Proposal for Supplement 1 to the 05 series of amendments – Regulation No. 48

This document corrects ECE/TRANS/WP.29/GRE/2011/32. The changes are shown in red. It is the result of discussions on GTB TF CAVGS to satisfy support of this group for Polish proposal. It answers for time being expectation to remove present problem of artificial over 2,000 lm and LED automatic levelling requirements and to give GTB TF CAVGS time and possibility to safely prepare more advanced scientific and research based new solutions.

The above limits and the initial aiming values are summarized in the diagram below.

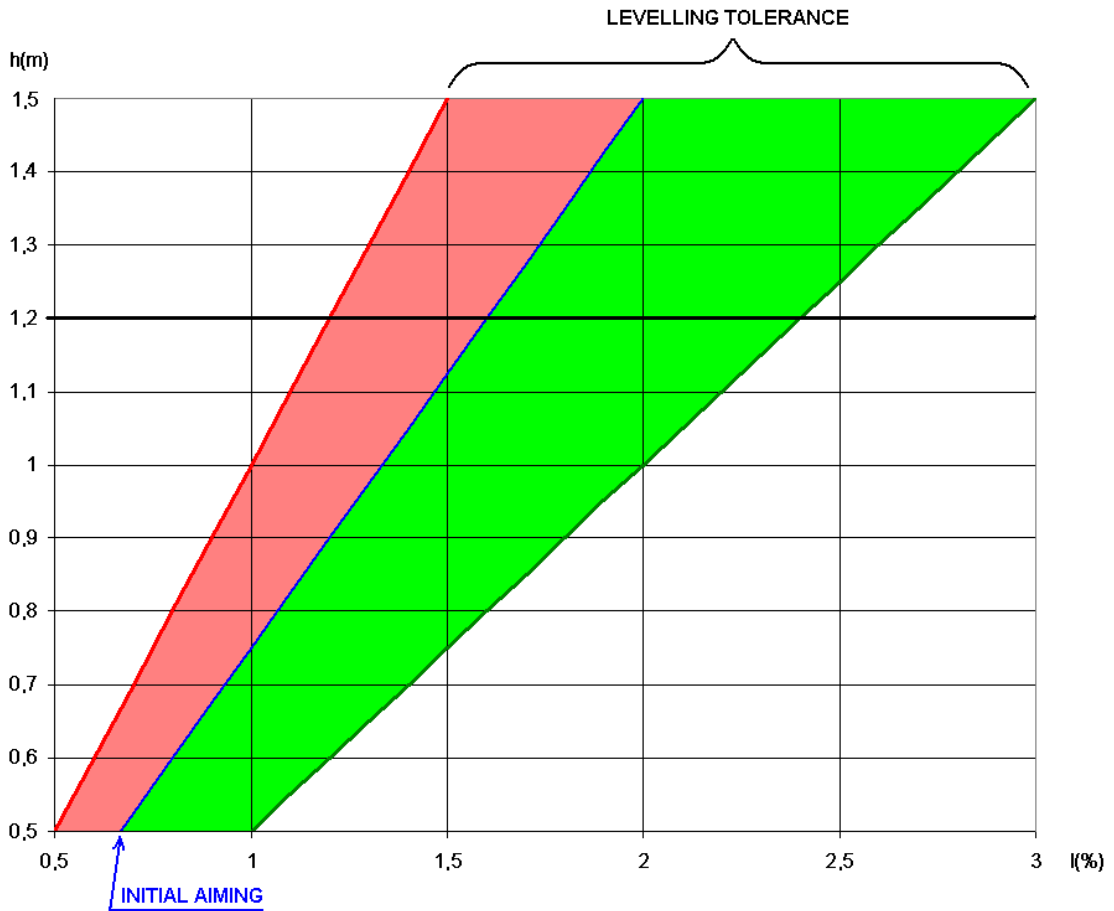
"6.2.6.1.2. Depending on the mounting height in metres (h) of the **dipped-beam headlamp reference axis, the vertical inclination of the cut-off of the dipped beam, (in the direction of the reference axis) measured on the unladen vehicles, taking in account 0.1 per cent accuracy, shall have the value of initial aiming for which the horizontal part of cut-off crosses the surface of flat horizontal road at the distance of 75 m from the headlamp.**

The aiming limits under all the static conditions of Annex 5 should be such that the distance of crossing of the vertical part of cut-off with road surface shall remain between [50 m] and [100 m].

limits: ~~between 0.5 per cent and 2.5 per cent~~
initial aiming: ~~between 1.0 per cent and 1.5 per cent~~

limits: ~~between 0.5 per cent and 2.5 per cent~~
initial aiming: ~~between 1.0 per cent and 1.5 per cent~~

limits: ~~between 1.0 per cent and 3.0 per cent~~
initial aiming: ~~between 1.5 per cent and 2.0 per cent~~

limits: ~~between 1.0 per cent and 3.0 per cent~~
initial aiming: ~~between 1.5 per cent and 2.0 per cent~~
